# **Town Creek Restoration Project – Option B Year 3 Monitoring Report**

**DMS Project ID Number – 95026; NC DEQ Contract No. 003990**

**Subject:** Task 9: Annual Final Monitoring Report – Monitoring Year 3 & Response to Comments  
Town Creek Restoration Project – Option B  
Yadkin River Basin – CU# 03040105 – Stanly County, NC  
NCDMS Project ID No. 95026; NCDEQ Contract No. 003990

**RIGHT BANK**

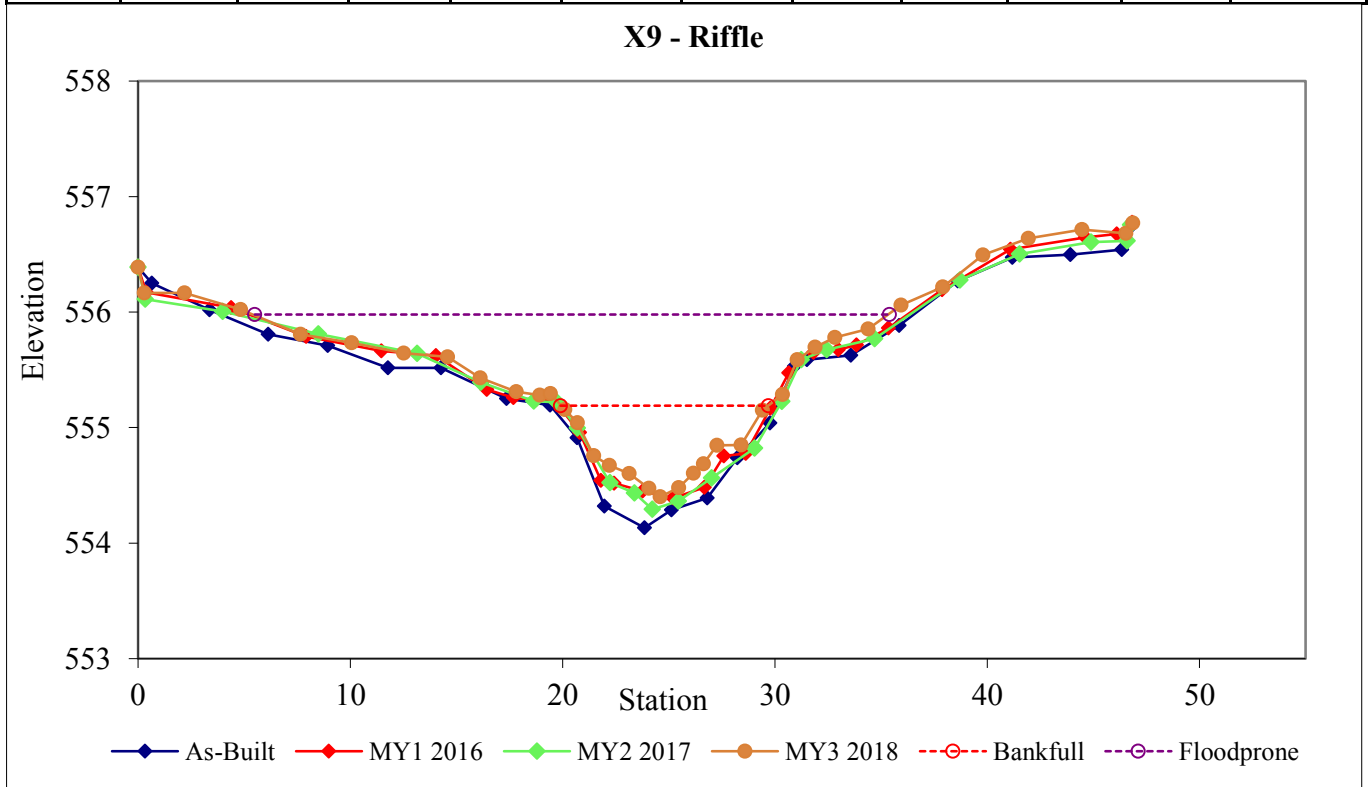
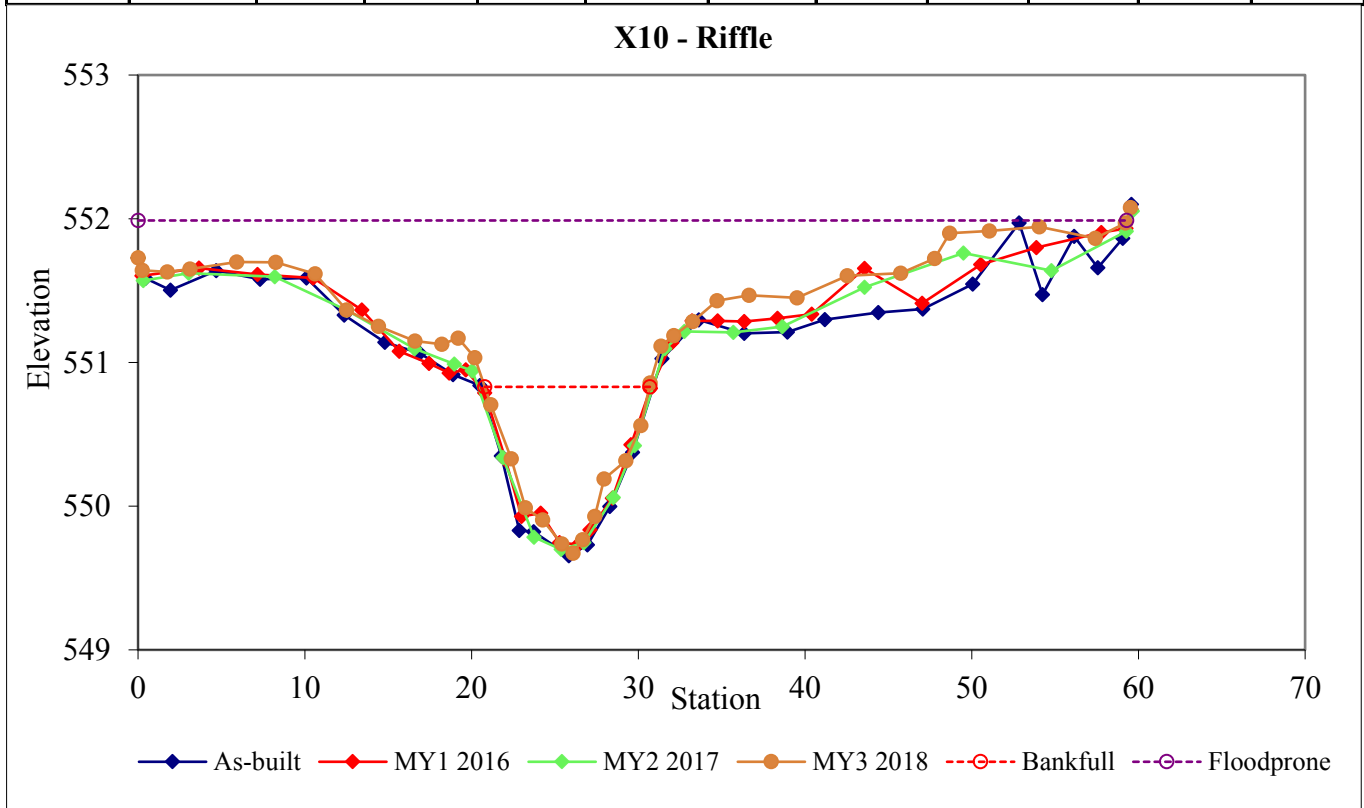
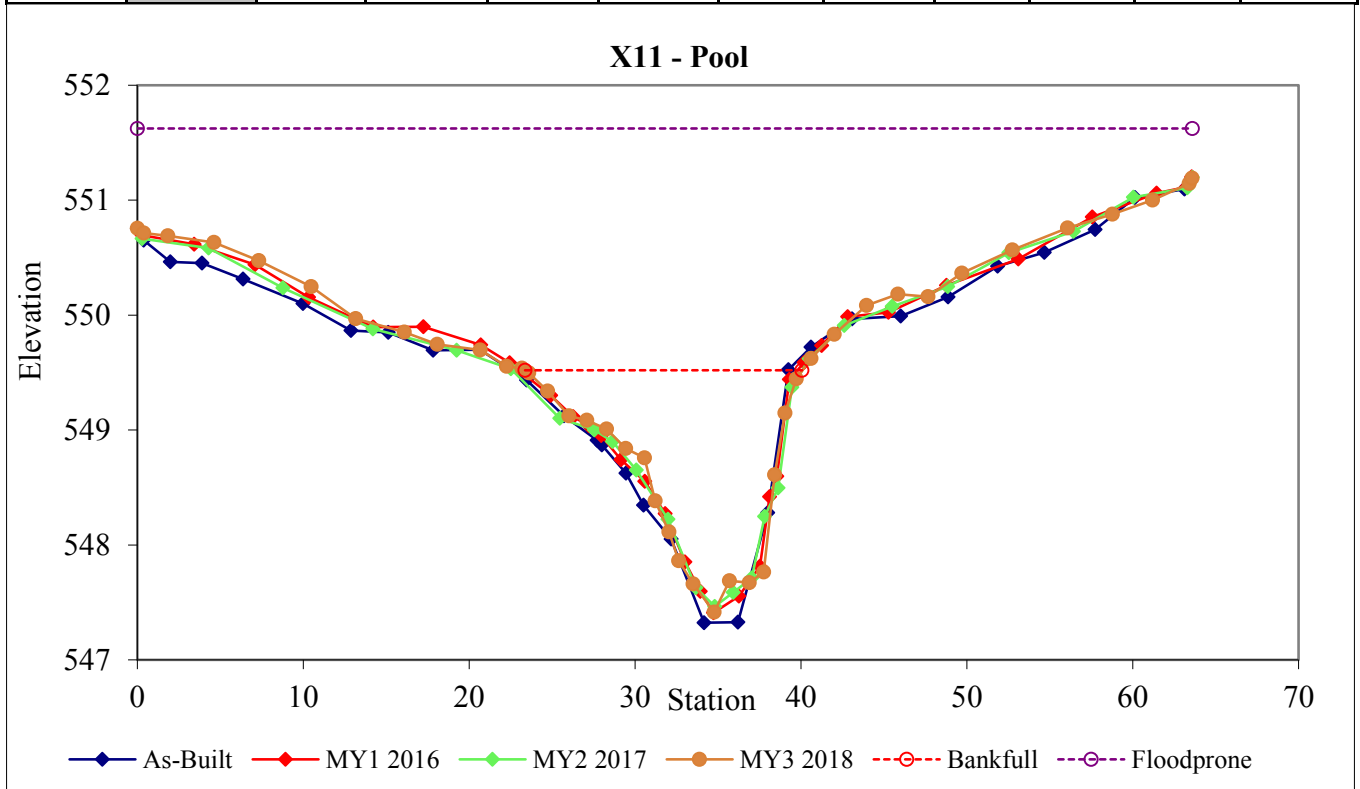
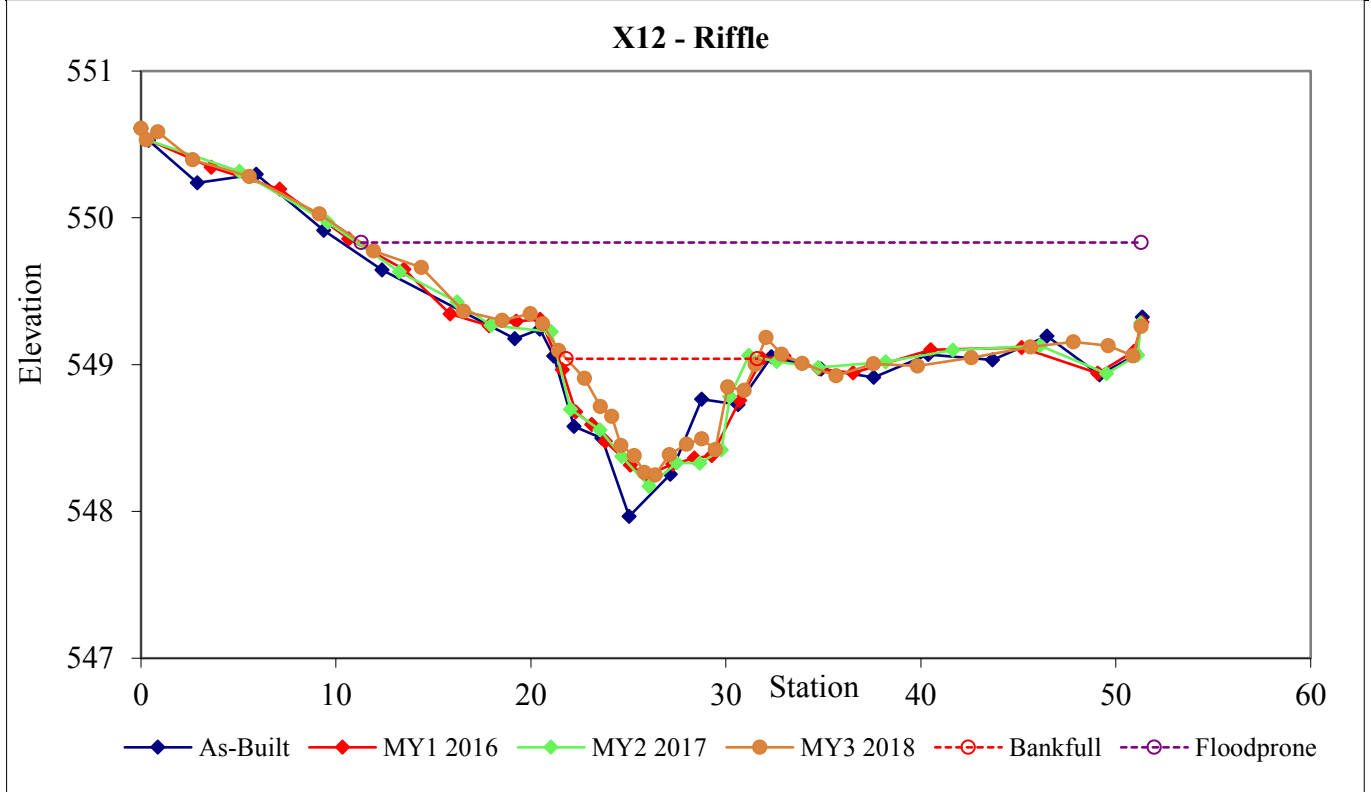
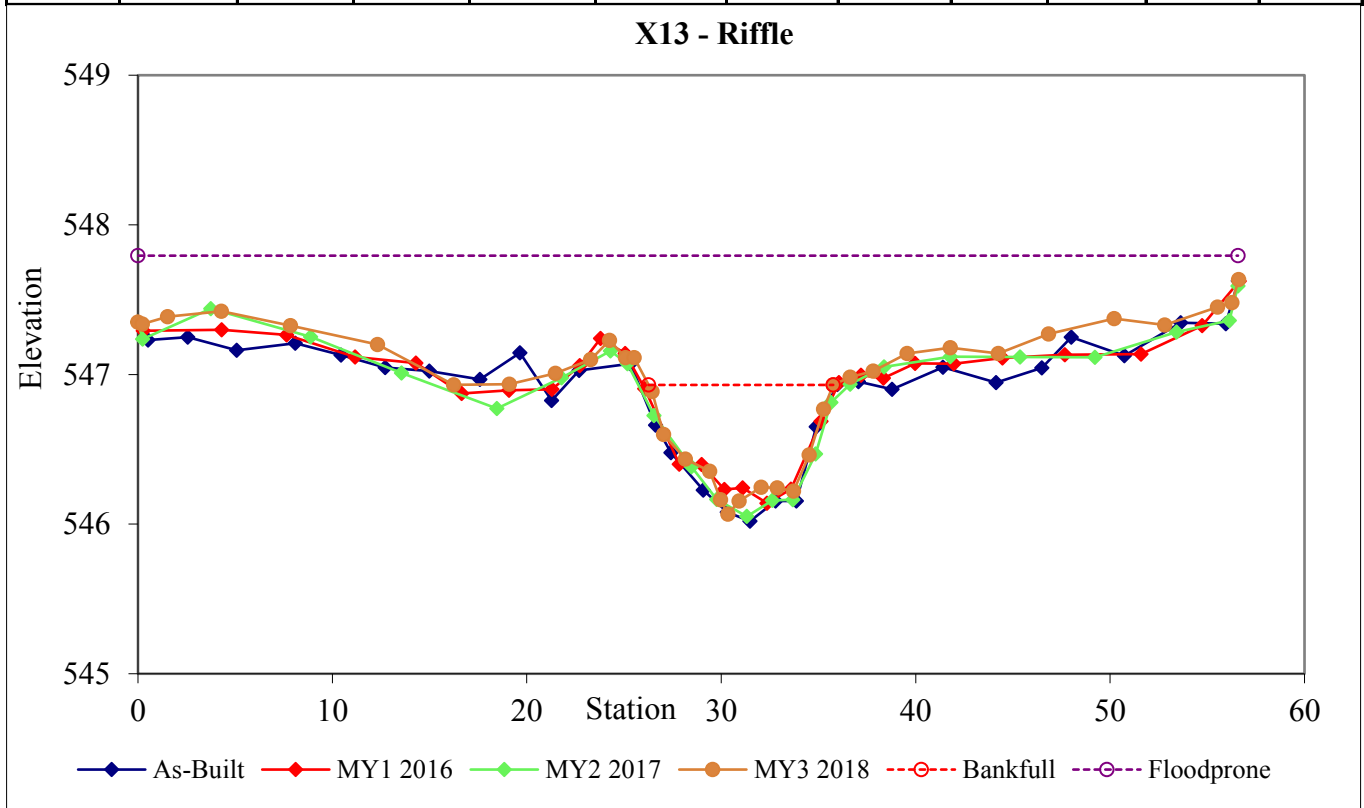
**Cross Section Graphs** – should indicate whether it is a pool or a riffle. Understood that the x-section table has this information, but it also needs to be on the graphs so the reader can have some context without having to flip back and forth.

**Response** – *The indication of whether the cross-section is a riffle or pool has been added to both the cross-section heading and the graph for each cross-section.*
